**IN THE LAND & ENVIRONMENT  
COURT OF NEW SOUTH WALES**

Proceedings 2022/279591

**GOLDCORAL PTY LIMITED**

**Joint Bushfire Expert Report**

Figure 01: Mark-up showing required turning areas

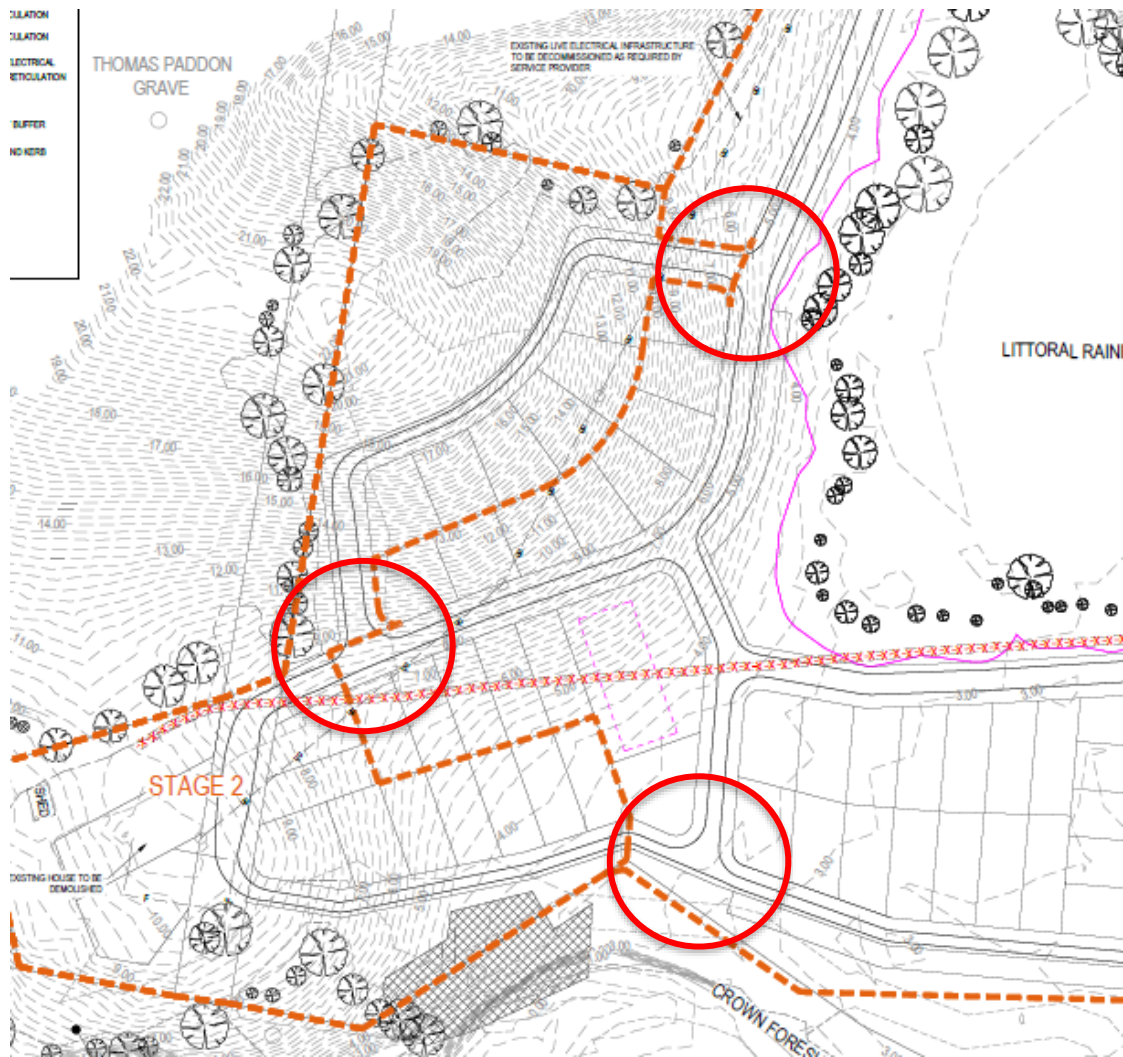
While the experts acknowledged that the physical Stage 2 road works do not form part of this application, and are the subject of a future application, they agree that the one-way section of Road 9 in front of Lots 123-128 should be increased to a two-way Perimeter Road. This is to include a minimum 8 metre carriageway, with all parking outside.

In addition, suitable turning for a Category 1 fire appliance as described in Figure A3.3 of PfPB shall be provided at the locations nominated in Figure 01 below until such time the continuation of the road network in Stage 2 is completed. These turning locations are to have a hydrant point located within 20 metres.

Alternatively, temporary linking trails, generally consistent with the road alignment shown for Stage 2, can be provided for attending fire services. These trails are to have an all-weather surface capable of accommodating a fully loaded fire fighting appliance and a minimum 4 metre carriageway.

16. That suitable turning for a Category 1 fire appliance as described in Figure A3.3 of PfPB shall be provided at the locations nominated in Figure 01 of the Joint Bushfire Expert Report until such time the continuation of the road network in Stage 2 is completed. These turning locations are to have a hydrant point located within 20 metres.
17. That a strategic fire fighting platform be provided at a point along the section of Road 2 fronting proposed Lots 93-94, 97-98, 101-101 and 105-106 (one-way road). The strategic fire fighting platform is to comprise of an additional 2 metre width (totalling 6m) for a 20 metre length, and a hydrant point.

Figure 02: Extract from Typical Road Sections prepared by Arcadis (dwg no IRG-AAP-DA-00-DRG-CV-0241, issue02)

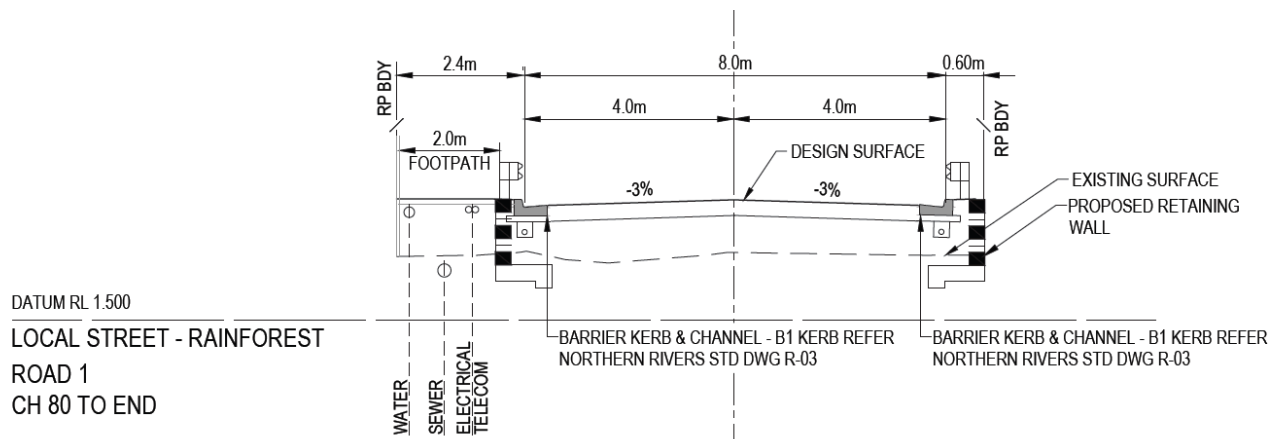
The experts agree that the current proposal has increased the carriageway of the road (Road 1 – formally Road 5) which separates the two rainforest lots to 8 metres.

In relation to Road 1 the Engineering Services Report prepared by Arcadis states:

*.....The adopted cross section shown on the engineering drawings in Appendix A, shows an 8.0m wide pavement carriageway with no allowance for on-street parking. Safety barriers (guard rails) have been adopted on both sides of the road to help in minimizing the total width.*

No verge is proposed on the northern edge of the road. Along the southern edge an expected 2.0m wide elevated platform clear of obstructions will be provided as a pedestrian boardwalk connection between the wider sections of the road. The proposed services required to run along this road shall be provided beneath the pedestrian boardwalk, with the relevant services attached to the structure or otherwise buried beneath the boardwalk in a standard trenching arrangement.
